ADDENDUM NUMBER 03

DATE: 3/17/2023
PROJECT: MHS West Gym Floor Replacement
PROJECT NUMBER: 22-1724
OWNER: School City of Mishawaka
ARCHITECT: Abonmarche
315 W. Jefferson Blvd.
South Bend, IN 46601
TO: Prospective Bidders

DRAWING T1.1 – TITLE SHEET

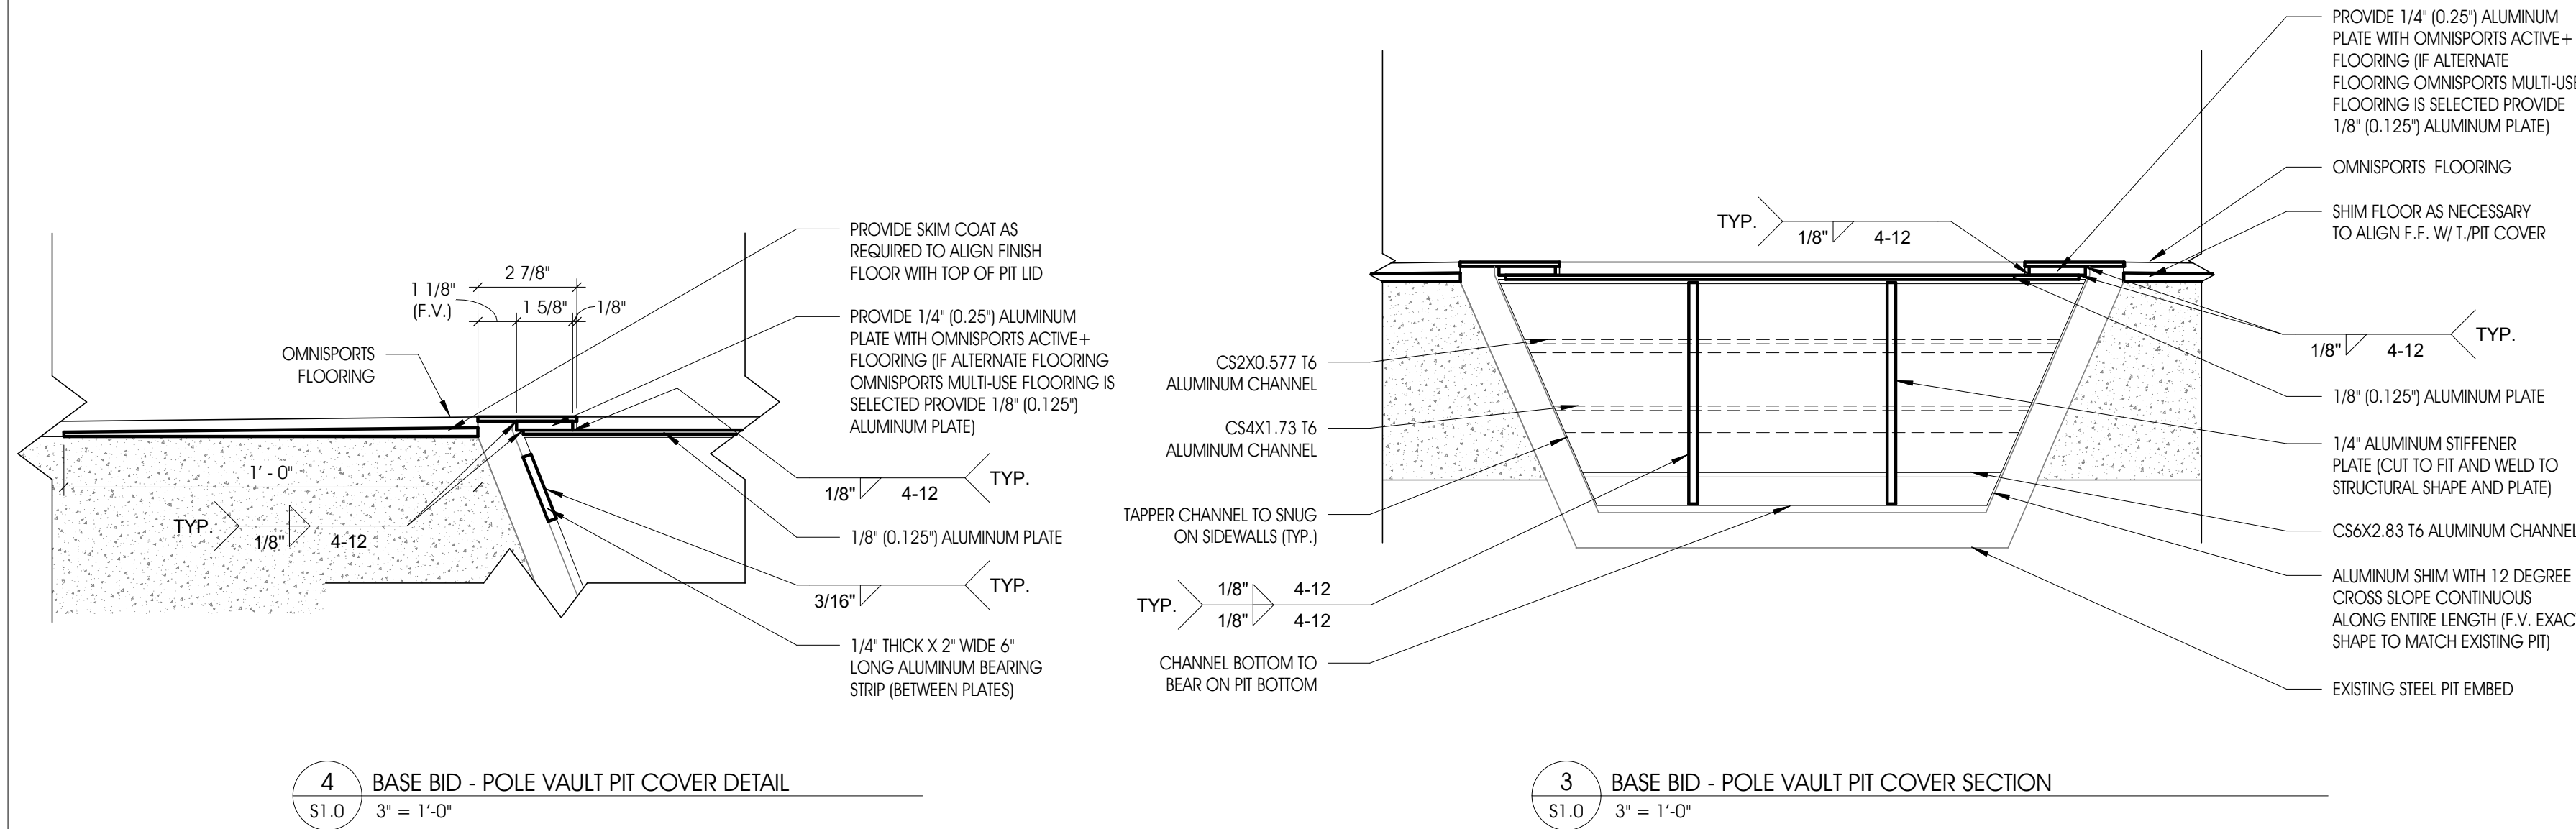
2) **DELETE** Alternate #3 – Bleacher Wheels
